# **Sony Proposals for Nordig-T meeting**

24 Aug 2016

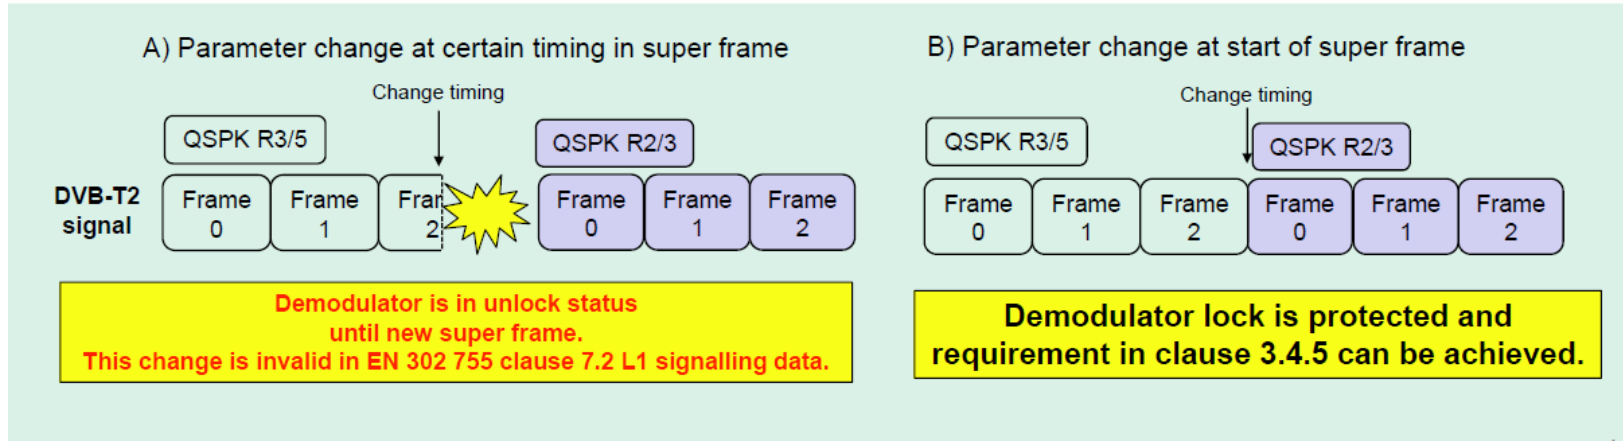
- Small relaxations are requested to satisfy proposed Nordig Unified Specification under all traffic loadings, not just the traffic loadings used in the Nordig Unified Test Plan.
- It is important to carry on using bursty interferers in the Nordig Unified Test Plan to detect un-optimised tuner designs which can show very large degradations of many dB

- Small relaxations are requested to satisfy proposed Nordig Unified Specification under all traffic loadings, not just the traffic loadings used in the Nordig Unified Test Plan.
- It is important to carry on using bursty interferers in the Nordig Unified Test Plan to detect un-optimised tuner designs which can show very large degradations of many dB

Band	Pre <TBD>			Post <TBD>		
	UL(FD D1&2)	UL(FD D3-6)	DL(FD D1-6)	UL(FD D1&2)	UL(FD D3-6)	DL(FD D1-6), SDL 1-4)
VHF	46	46	46	48	48	48
K21-37	46	46	46	48	48	48
K38-47	43	43	46	45 → 44	45	48
K48	33(T) / 38(T2)	43	46	43 → 42	45	48 → 47
